LOT 11-A, 11-B, BLOCK 1, AIRPORT INDUSTRIAL PARK			
SITE PLAN			
DRAWING: 200601-SITE.DWG	DRAWN BY: J.T.	DATE: 4-05-06	SHEET # 1 OF 1

LOT 11-A, 11-B, BLOCK 1, AIRPORT INDUSTRIAL PARK SITE PLAN

**LOT 11, BLOCK 1, AIRPORT INDUSTRIAL PARK
GRADING AND DRAINAGE PLAN**

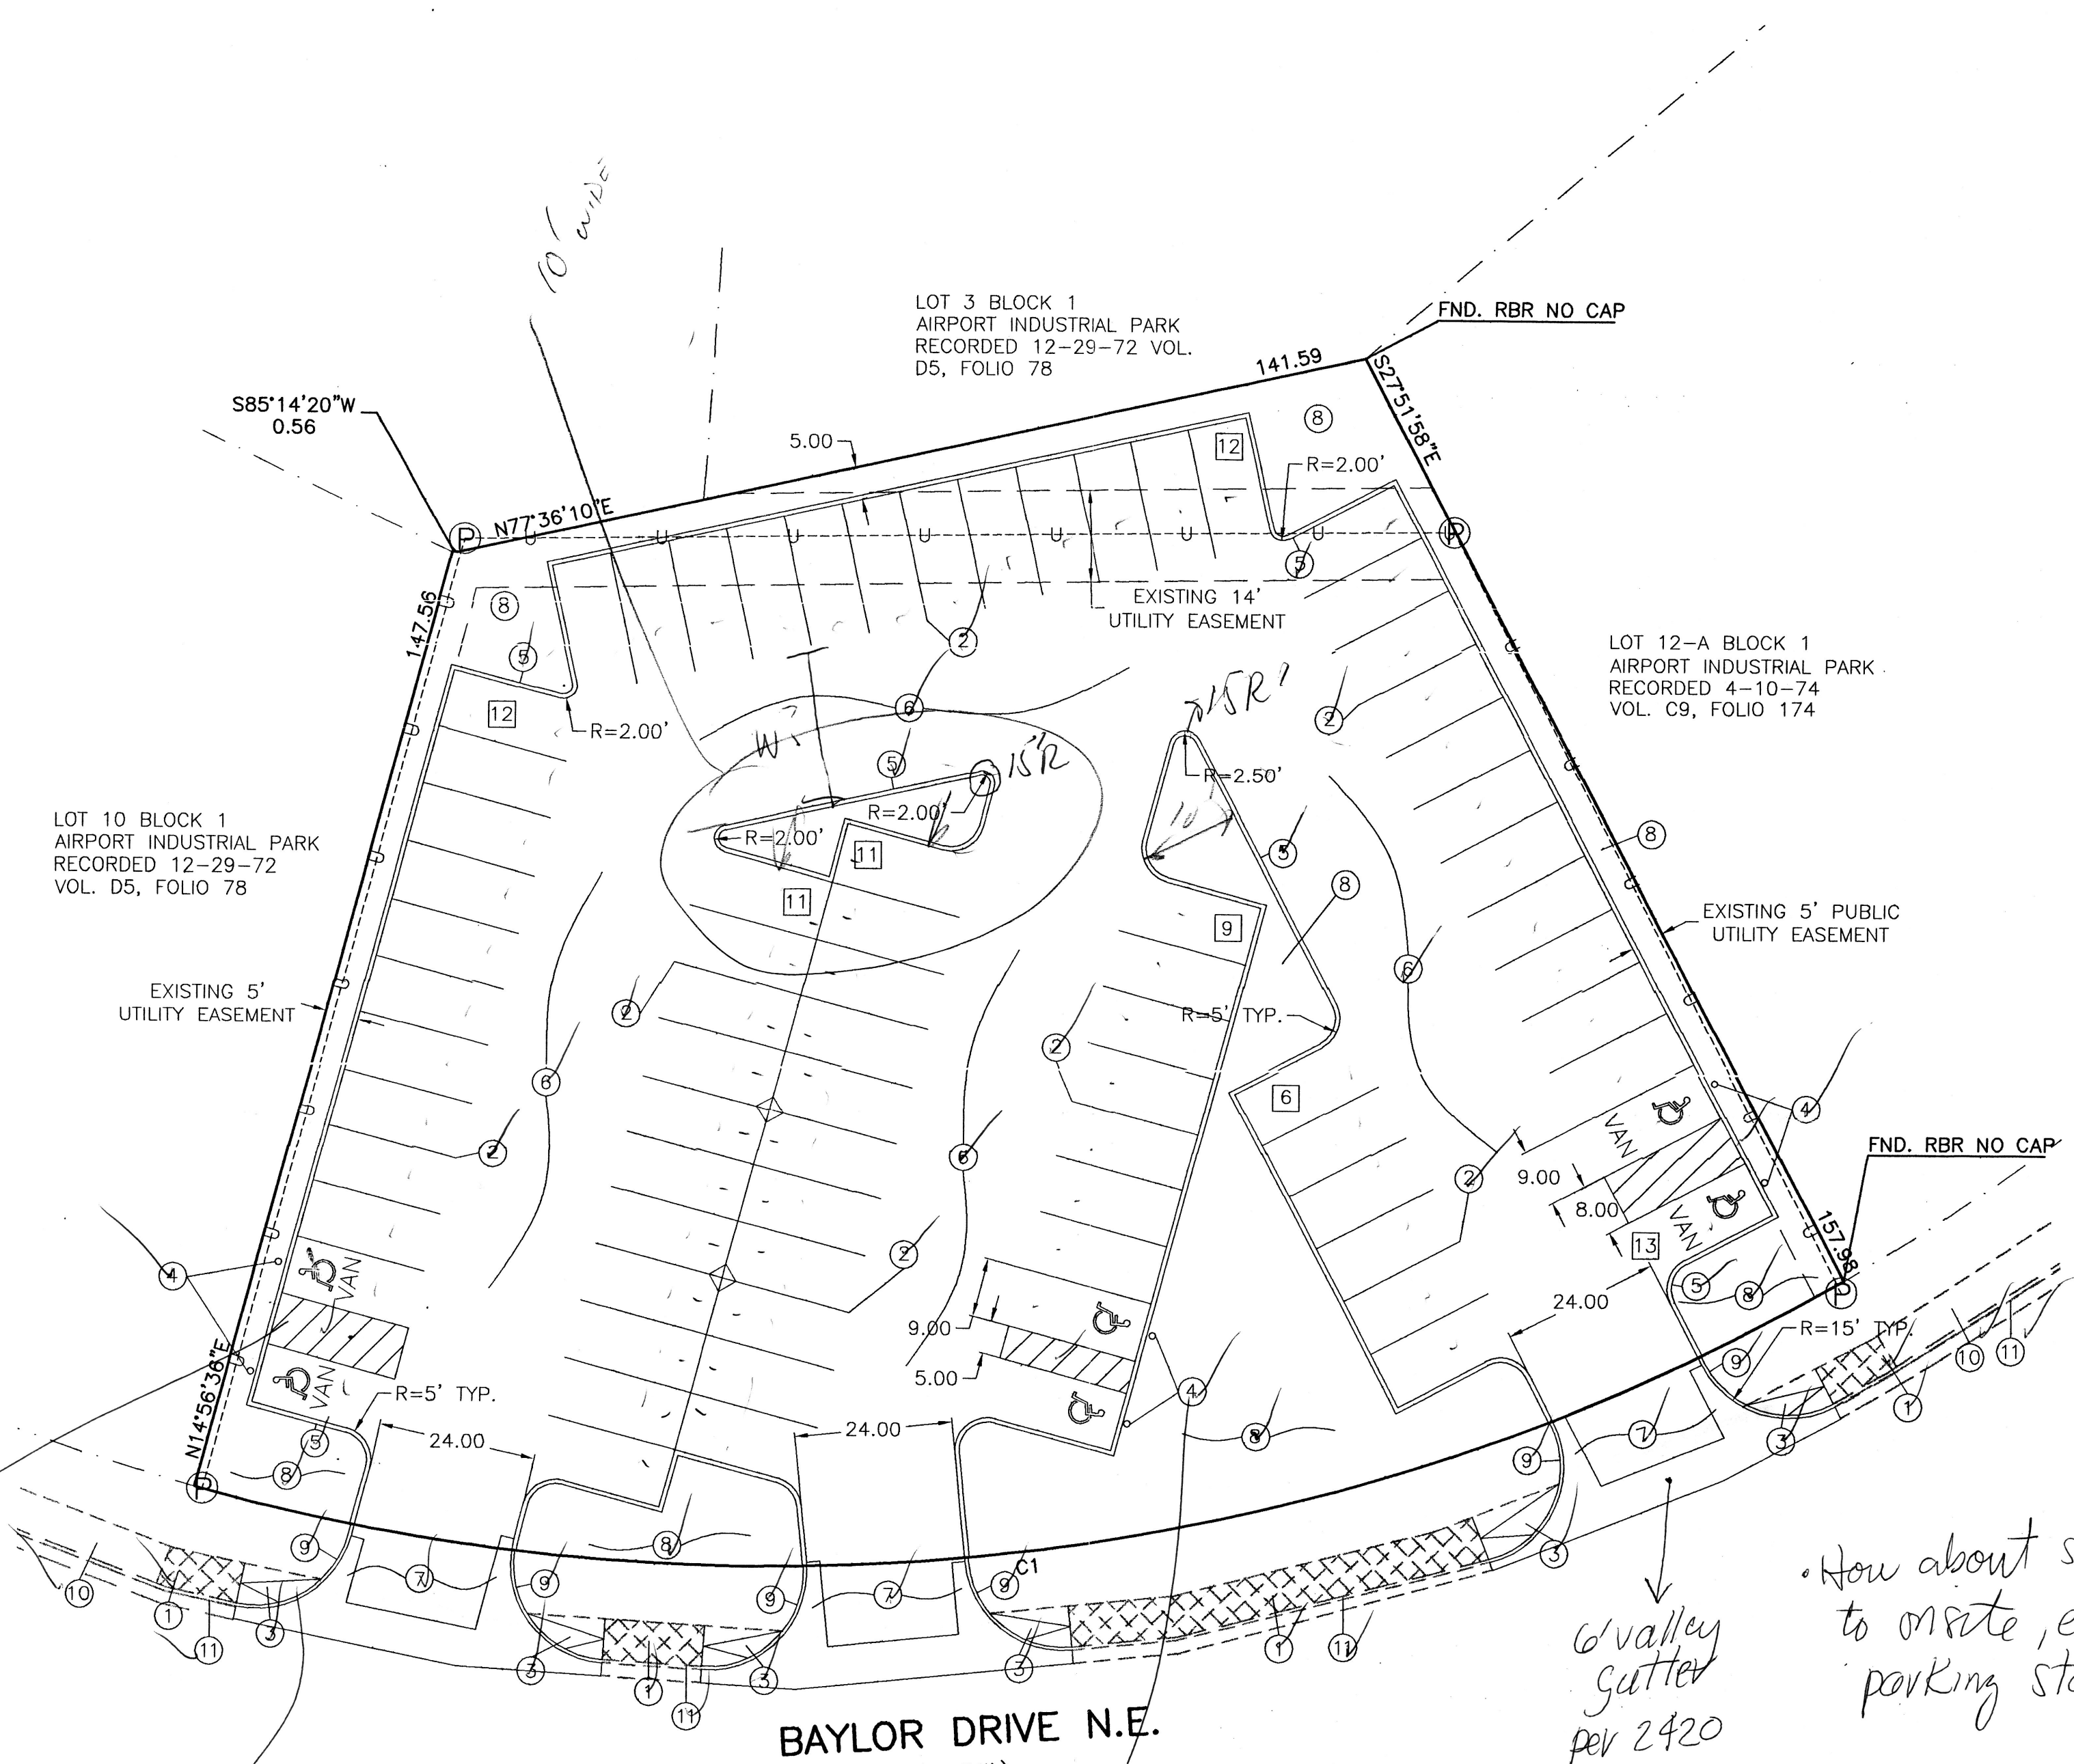
(typ.) so, we ramp vs sidewalk connection

Provide 3' @ 2% Cross slope (C.S.) for ADA access route

R? provide curve data

this is not van accessible

How about sidewalk connection to on-site, especially to ADA parking stalls?

At what locations do you transition (9) to (5)

location of sign needs to be 2' back of curb for vehicle overhang

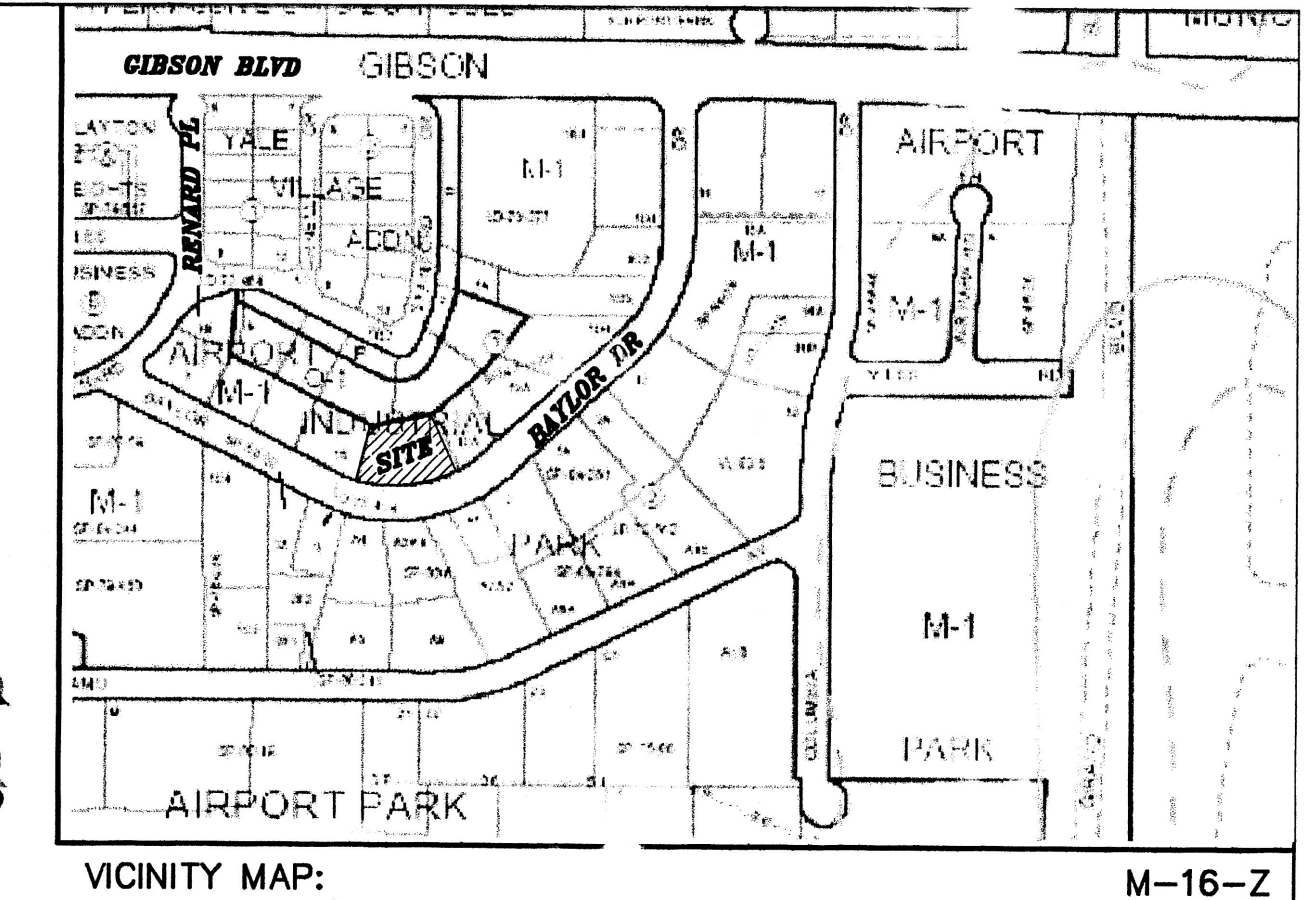
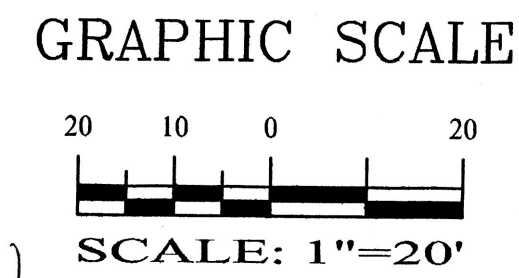
valley gutter per 2420 (typ)

- 1. EXISTING 6" SIDEWALK.
 - 2. 9' X 20' PARKING SPACE.
 - 3. NEW UNIDIRECTIONAL WHEELCHAIR RAMP PER COA STD. DWG. 2426 w/ truncated domes
 - 4. INSTALL HANDICAP SIGN, SEE DETAIL THIS SHEET.
 - 5. NEW PINNED CURB PER COA STD. DWG. 2415B provide type
 - 6. NEW ASPHALT PAVING AREA.
 - 7. NEW ENTRANCE PER COA STD. DWG. 2426
 - 8. LANDSCAPE AREA
 - 9. NEW CURB PER COA STD. DWG. 2415A
 - 10. EXISTING SIDEWALK
 - 11. EXISTING CURB AND GUTTER
- Is Landscaping prepared w/in COA ROW? If so, provide clear site line and do you need streetscape agreement (on COA ROW only)*
